Optimal Ref: 21P54

STORMWATER MANAGEMENT PLAN

14 Mirrool Street, North Narrabeen (DA2023/1770)

Figure 8 – MUSIC model (Option 1)

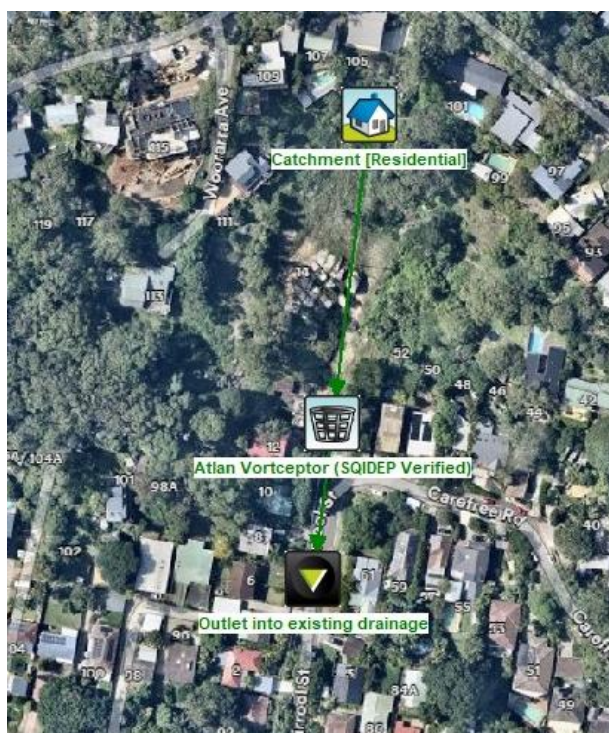
The stormwater management plan prepared by Optimal Stormwater, dated 23 May 2023, made an offer to contribute financially toward a stormwater treatment solution on public land, seemingly in lieu of stormwater treatment on private land. Although innovative the proposal is not supported. The stormwater treatment devices for the subdivision must be located on the private land and maintained by the owner to meet the water quality targets at all times.

- Meet the WMD Policy Table 5 – General Stormwater Quality Requirements, and demonstrate compliance by providing a model, preferably a Model for Urban Stormwater Improvement Conceptualisation (MUSIC), or an equivalent;
- Show the rainwater tanks required by BASIX in the stormwater plan; and
- Ensure all stormwater treatment measures for the subdivided lots are located on private land.

Several options to treat the stormwater were considered, and based on Council's advice that they preferred on-lot treatment, we have designed our solution in line with this preference. The Lot scale bio-filtration controls were able to achieve the results in MUSIC shown below.

Erosion and generation of suspended solids is a risk, but only during the construction period and that can be addressed through site controls. A screenshot of the model appears in **Figure 8** below.
